COLUSA COUNTY Airport Advisory Committee SPECIAL MEETING AGENDA

August 12, 2021

Request For Airport Advisory Committee

SUBJECT: Golden Roots Nursery (Ranveer Tumber) Greenhouse (Hoop Houses) Project

1"=200'

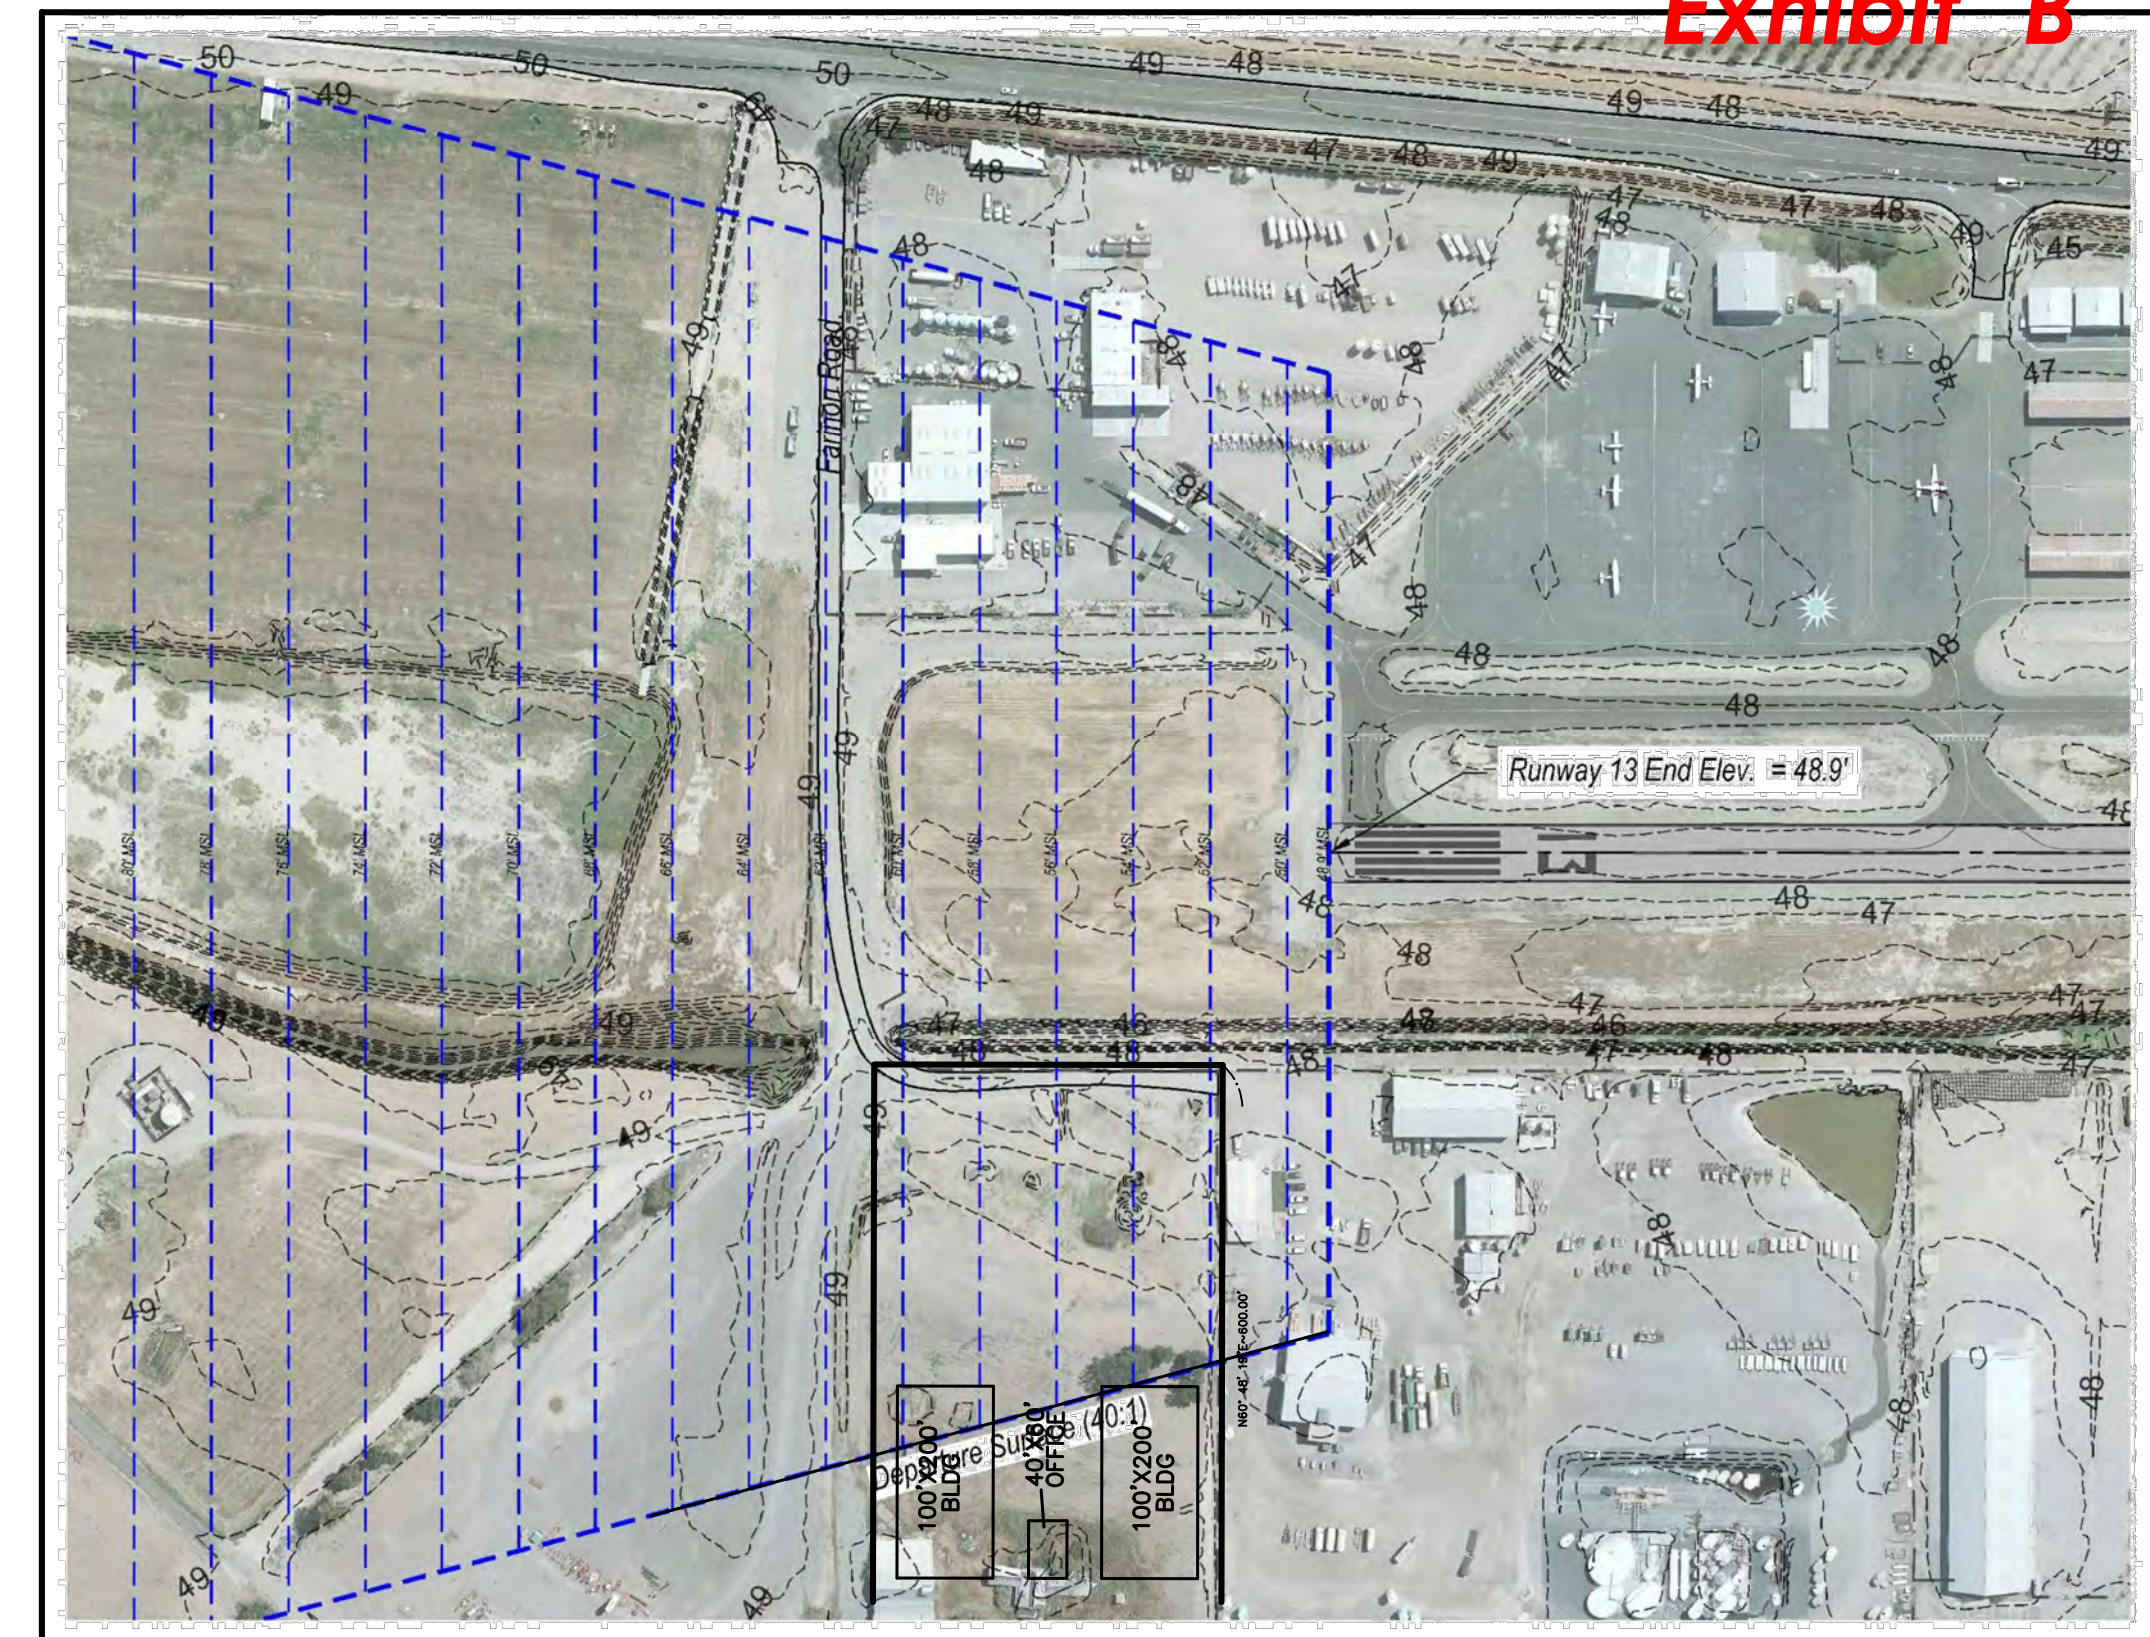
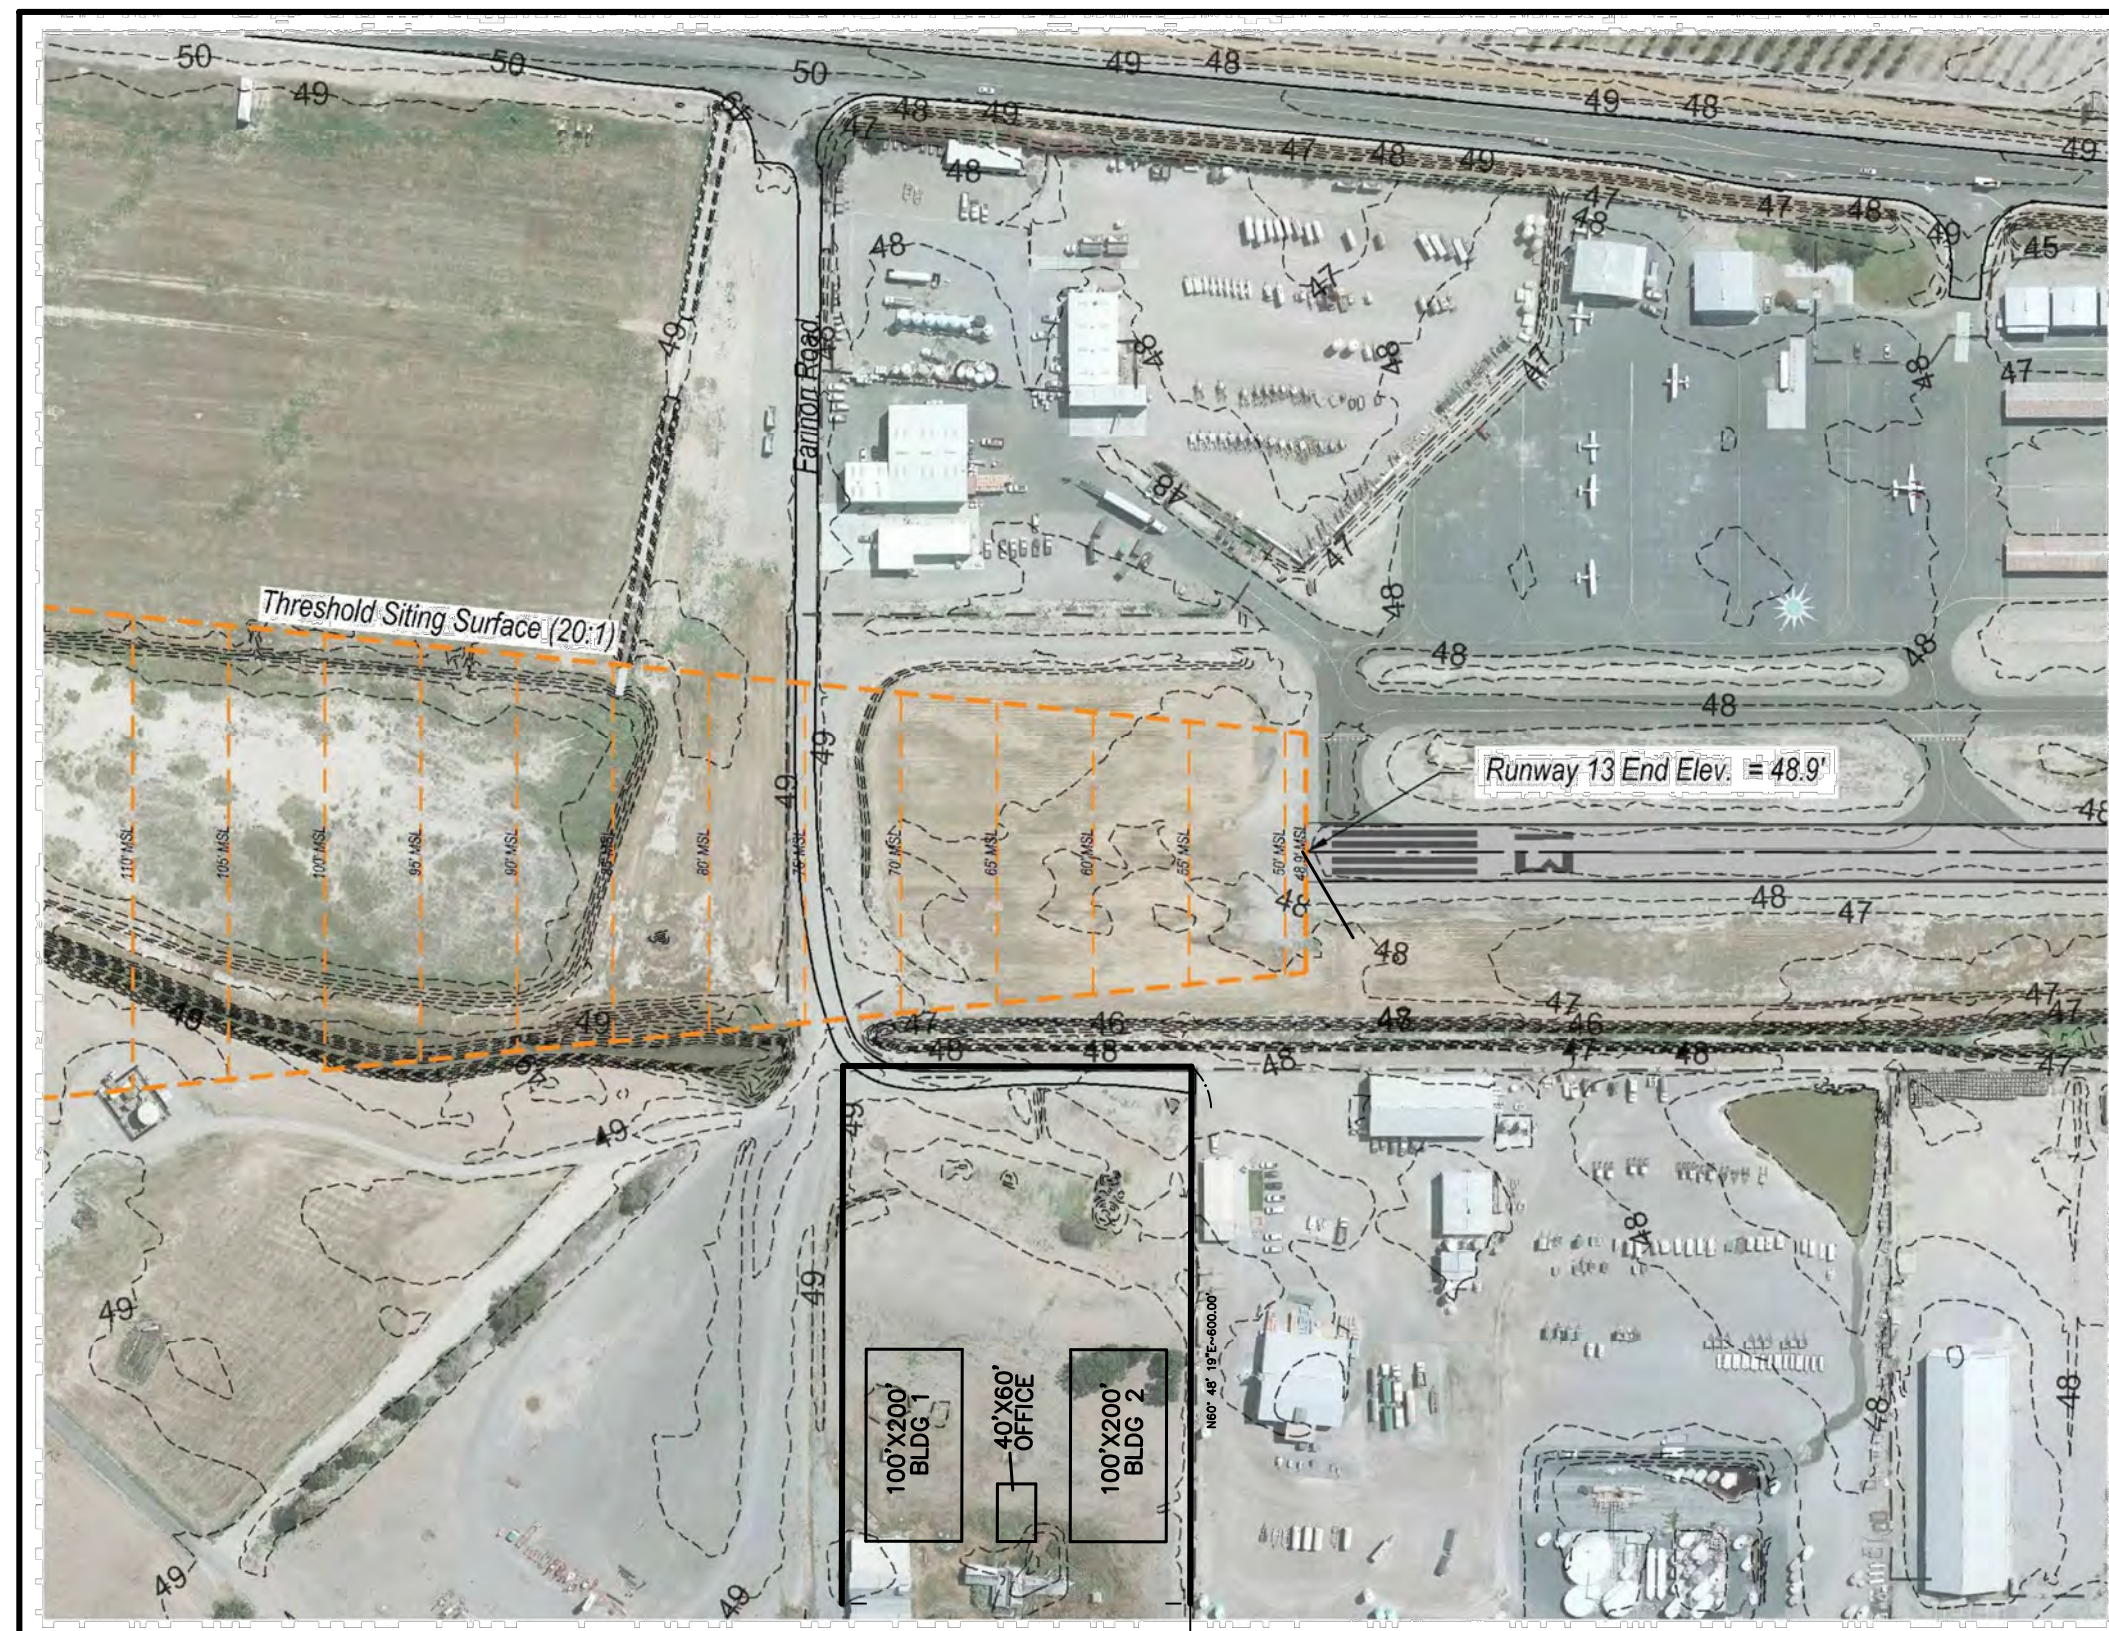
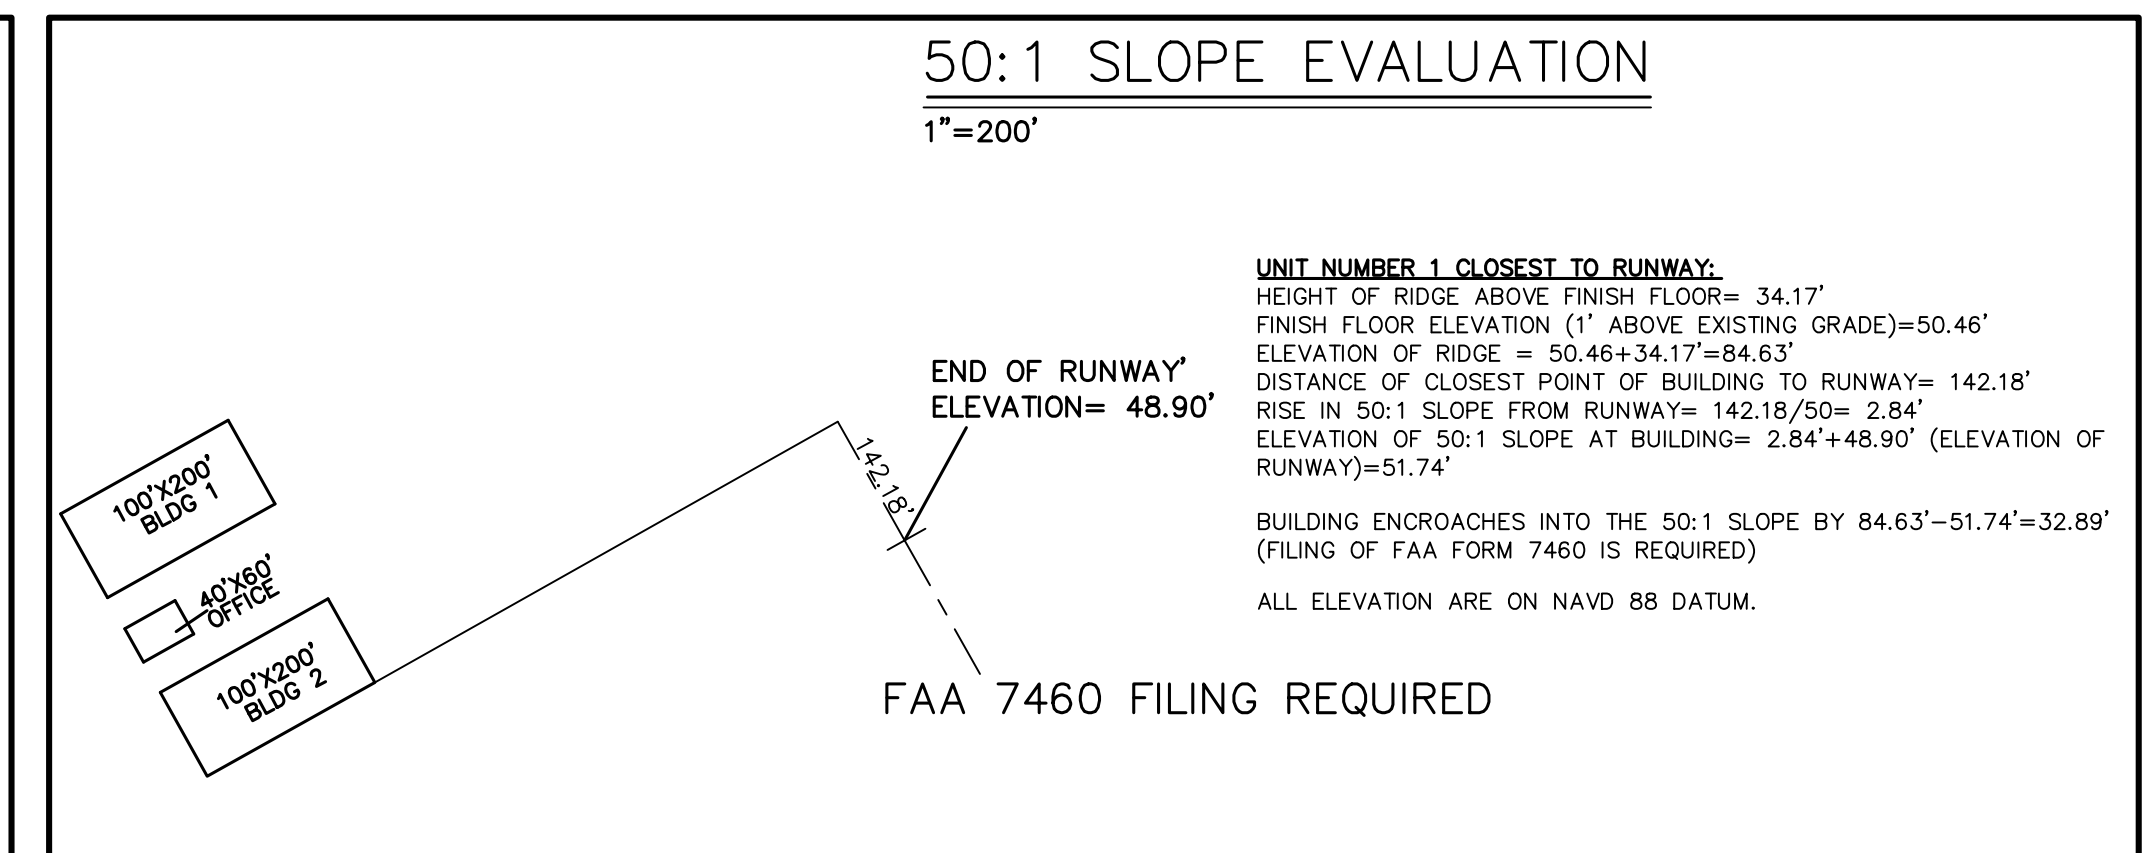
Exhibit "B" shows that the subject site is located in the ALUCP's B1 and C1 Compatibility Zones. As shown in Exhibit "C" (Site and Building Plans), the industrial buildings would be located on the westerly half of the parcel in Zone C1 and the outdoor storage and truck parking would be located on the easterly half of the parcel in Zone B1. The proposed use within the buildings would be considered a "Light Industrial - Low Intensity" use and it is a permitted use in the C1 Zone. Examples of Light Industrial - Low Intensity uses include wood product facilities with a person density of less than 350 sq.ft. per person and does not include the storage of hazardous materials. The proposed use meets these criteria. The proposed use would have outdoor storage in the B1 Zone which is also permitted use, provided an airspace obstruction does not occur (the airspace discussion follows under the height section).

Given the degree of the building encroachments into the various regulated height elevations, staff believes that the information from the FAA's hazard determination should be considered prior to a formal building height consistency determination being made. The Commission could provide an initial consistency determination for issues where the necessary information has been provided that allows for issues to be fully analyzed. However, for issues such as building height where a critical piece of information is not yet available, staff does not believe a formal determination either for or against can be made with any degree of certainty.

7. The property is located within the Airport's Critical Airspace Protection Zone (ALUCP Map 3B, Airspace Protection Surfaces). Project proponents have submitted conceptual plans for two buildings in the easterly half of the property to the FAA for a hazard identification study. The results of the conceptual FAA Aeronautical Study No. 2021-AWP-2877-0E and Aeronautical Study No. 2021-A WP-2883-0E is that objects that exceed a height as little as three feet could penetrate an Airspace Protection Zone.
